Site Inspections of Aqueous Film Forming
Foam Usage at Multiple United States Air Force
Installations in U.S. EPA Regions 6 and 9
Contract # W912BV-15-C-0082

Document – Response to Comments and Redline Draft Final QAPP Addendum for Site Inspections of Aqueous Film Forming Foam Usage at Edwards AFB, Oneida Total Integrated Enterprises, August 2016

Document – Response to Comments and Draft Final QAPP Addendum for Site Inspections of Aqueous Film Forming Foam Usage at Edwards AFB, Oneida Total Integrated Enterprises, August 2016

Figure 15 Former Nozzle Spray Test Area

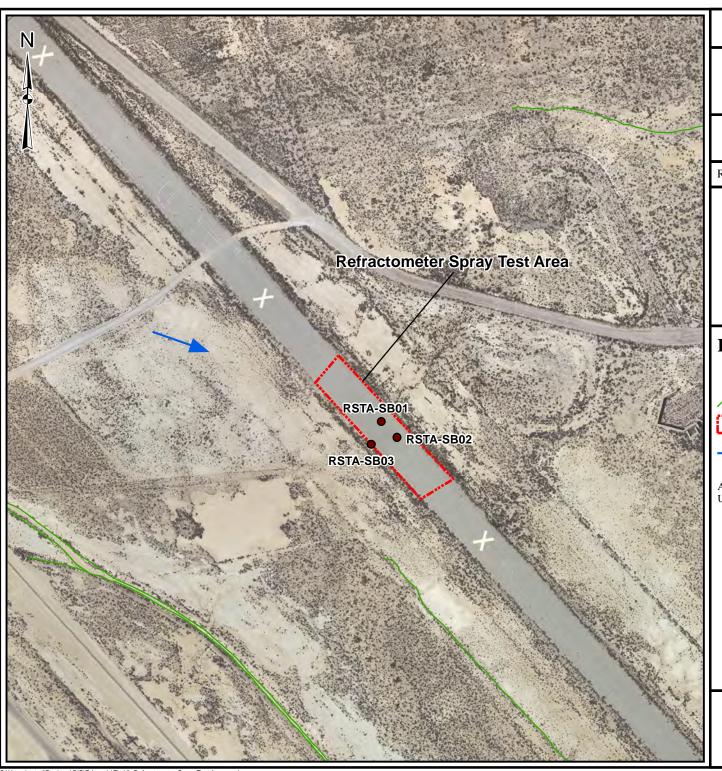
Item	General Comment	Response
Item	General Comment for the PFC characterization. DTSC Response. Understood. r. Former Nozzle Spray Test Area. Located in OU 1 southeast of Site 51. A review of the OU 1 2015 water level map confirms the groundwater flow direction shown on Figure 15. No monitoring wells are proposed to be sampled and there are no nearby downgradient wells, but wells 52-MW56 and 52-MW06 (although fairly distant downgradient-approximately 1,000 feet to the east) might serve as downgradient sample locations. DTSC recommends these wells be sampled. DTSC Response. Understood. DTSC reviewed Figure 15 and identified	direction Air Force Response. Comment acknowledged. r. Disagree. Well 52-MW56 is not screened across the water table and, therefore, not suitable for sampling for PFASs. Groundwater samples will be collected from the three soil borings. The goal of the SI is to confirm the presence or absence of PFASs from Air Force-mediated AFFF releases at the 23 SI areas. It is not in the scope of the SI to determine vertical and lateral extent. Therefore, well 52-MW06, approximately 1,000 feet downgradient to the east, will not

a fairly large dark area which implies substantial vegetation in the northern portion of the designated site. Assuming this is the case, the vegetation suggests an area of preferred ponding/infiltration. The closest boring, FNSTA-SB01 is located some distance south of this vegetated area. DTSC strongly recommends FNSTA-B01 be moved to this area. s. Refractometer Spray Test Area. Located in OU 2 south of Site 29. The PA is referenced as the basis for the groundwater flow direction shown on Figure 16, but this information is not provided in the PA. There are no monitoring wells in the area, but based on GW flow direction for Sites	be included in the sampling plan. Air Force Response. Clarification: Observations made during the March 2016 Site Visit confirmed that the vegetation apparent in the northern portion of the site is a large tree. Boring FNSTA-SB01 was plotted as close to the tree as practical to still provide safe access for the workers, drilling rig, and its appurtenances. No changes were made in response to this comment. s. Clarification. The PA states "The groundwater flow at

29 (to the south) and Sites 5/14 (to the north), it is reasonable to assume flow direction is to the east-southeast as portrayed on Figure 15. No downgradient wells are available to be sampled and will therefore be a likely data gap for PFC characterization of this site. DTSC Response. DTSC recognizes the response, but the site identification appears based on no verifiable features and instead on the recollection of an individual. Since the borings are fairly close spaced (which DTSC is not contesting), we are putting a lot of faith that they are located specifically where the spill occurred. Definable downgradient groundwater sampling locations would provide added assurance that sampling has been performed in the correct location of the spill and better determine if groundwater has been impacted. This needs to be considered upon review of the SI sampling results.	Edwards AFB is generally toward Rogers Dry Lake", which is to the east-southeast as shown on Figure 15. Also, during the site visit, the fire department chief indicated that this location with areas selected for sampling will likely result in the detection of significant PFAS concentrations. Air Force Response. Clarification: Because the tests are required by Fire Department regulation to be both routine and systematic to calibrate and confirm the proper functionality of their equipment, a fixed location has been used for the Refractometer Spray Test Area. The features used to verify the location of the Refractometer Spray Test Area during the March 2016 Site Visit were sets of orange cones delineating the area, and painted markings on the asphalt pavement used

Figure 17 Muroc Golf Course

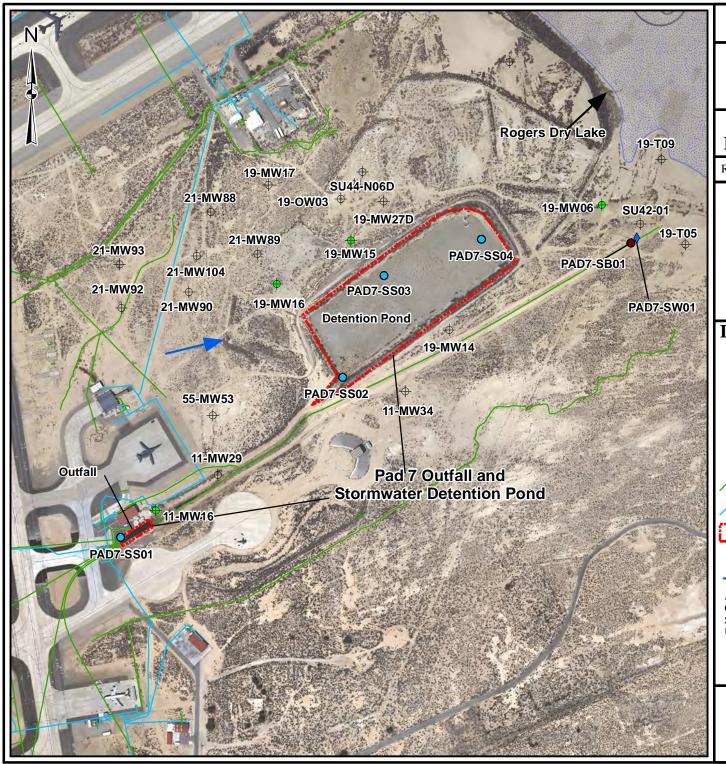
Item	General Comment	Response		
	t. Muroc Golf Course. Located west of OU 1. DTSC does not have environmental information for this area of the base. Figure 17 shows (regional) groundwater flow to the east, but groundwater flow is more likely radially outward from the golf course. The Plan proposes sampling well 259-MW01, which we assume is the only well in the area. Considering the likelihood that GW flow is radially outward from the golf course, sampling groundwater from only the single well in the area will provide only limited information in assessing the presence of PFCs. u. Pad 7 Outfall and Stormwater Detention Pond. Located in OU 1, adjacent to Sites 11 and 19. Based on a review of the 2015 water level figure for OU 1, groundwater flow direction might be more directly to the east rather than towards the east-northeast as portrayed on Figure 18. The Plan proposes sampling wells 11-MW16, 19-MW06, 19-MW15, and 19-MW16, but wells 19-MW16 and 19-MW15 are likely upgradient of the site and DTSC questions why these wells were selected to be sampled. DTSC suggests sampling downgradient wells 19-MW14 and 19-T05, which are southeast and east, respectively, of Pad 7 and well 11-MW68, which is east of the Outfall (note that 11-MW68 is not shown on Figure 18). DTSC Response. Even if the Air Force's east-northeast flow direction is correct, wells 19-MW15 and 19-MW16 are not downgradient and are not good candidates for sampling to meet the project DQOs. On the other hand, 19-MW14 does appear downgradient based on the flow direction arrow on Figure 18 and should be sampled.	by the Fire Department to quantifiably measure the distance and pattern of the spray test. The cones and markings are unfortunately not visible on the aerial photograph used as the base for Figure 15. t. Clarification. Based on consensus during the 18 May 2016 scoping meeting, well 259-MW01 was added to the SI sampling plan based on influence from the golf course pond as evidenced by detected trihalomethanes concentrations detected in the pond water. Comment acknowledged regarding limited information being provided from single well. u. Disagree. Based on Plate 1 in the OU1 GMSR for 2012, groundwater flow direction near the Pad 7 Outfall and Stormwater Detention Pond is east-northeast (AECOM 2015). No change was made in response to this comment. Air Force Response. Clarification. The Air Force believes wells 19-MW15 and 19-MW16, while not downgradient, will provided valuable information on PFAS concentrations in groundwater and will be retained for sampling. Disagree. 19-MW14 is not proposed for sampling because it is not screened across the water table.
